Product Change Notification

Date Issued :	March 14, 2025	PCN Number :	516689
Reason for Change :	Change to Product		
Description of Change :	This notice is to inform you that Molex Lincoln Nebraska is making a design change to the Mini Fit Sigma, (200453 series), 2ckt & 3ckt parts impacting the product in the attached list. There will be a change to the Form, Fit and Appearance of the Mini Fit Sigma, (200453 series), 2ckt & 3ckt parts, but the Function of those parts will not change.		
Reason for Short Notice :	Corrective Actions		
Assessment of Change :	Dimension analysis First Article Inspection		
Planned Implementation Date :	September 19, 2025		
Customer Sample Availability Date:	May 30, 2025		
Last date to request Samples by Customer :	April 28, 2025

Design change of Mini Fit Sigma, (200453 series), 2ckt & 3ckt parts
-- Adding clearance for better product mating

Before Picture

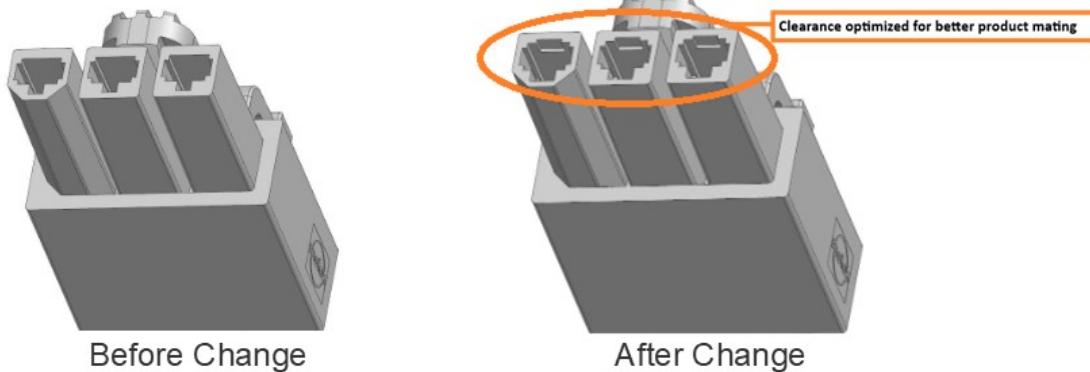
3ckt part shown below, change also being completed on 2ckt part

- To ensure continuous product quality Molex Lincoln Nebraska is making a design change to the Mini Fit Sigma, (200453 series), 2ckt & 3ckt parts.
 - Structure of part, as shown above, is going to be optimized to allow for better product mating.

- **Product Impact**
 - Function of parts will not be impacted by this optimization
 - Form, Fit and Appearance will be impacted as shown in after photo above
